REPORT NUMBER: 236/25

APPLICANT:	Mr John and Elisha Tsoutsikos
ADDRESS:	53 MARINE PDE SEACLIFF SA 5049
NATURE OF DEVELOPMENT:	Appeal Report Variation to Application ID 23037611 for the
	construction of a pair of two level detached dwellings, fences
	and retaining walls comprising the addition of a third level to
	both detached dwellings
ZONING INFORMATION:	Zones:
	Established Neighbourhood
	Overlays:
	Airport Building Heights (Regulated)
	Affordable Housing
	Character Area
	Local Heritage Place
	Prescribed Wells Area
	Regulated and Significant Tree
	Stormwater Management
	Urban Tree Canopy
	Technical Numeric Variations (TNVs):
	Minimum Frontage (Minimum frontage for a detached
	dwelling is 12m; semi-detached dwelling is 12m; row dwelling
	is 12m; group dwelling is 12m; residential flat building is 12m)
	Minimum Site Area (Minimum site area for a detached
	dwelling is 450 sqm; semi-detached dwelling is 400 sqm; row
	dwelling is 350 sqm; group dwelling is 350 sqm; residential flat

Compromise Plans:

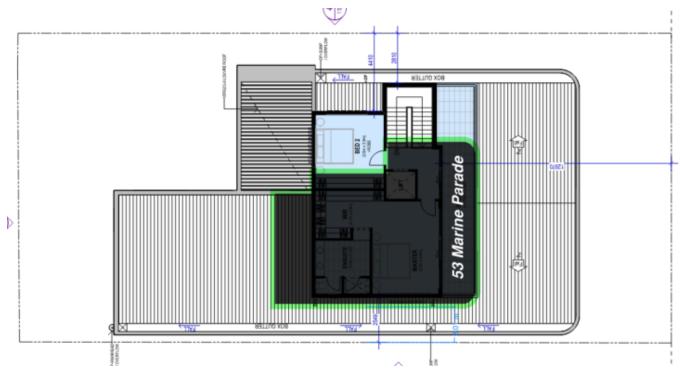
This is considered to reflect a positive improvement in further reducing the visibility of the 3rd level. As per the illustration below, the black envelope with green border highlights the new 3rd level envelope above the refused envelope, which is substantially closer to the southern side boundary. Bedroom 2, the stair case and part of the front balcony have been deleted:

53 Marine Parade has increased side boundary setbacks at the 3rd level, from 2.8 to 4.4 metres to 6 to 8.9 metres.
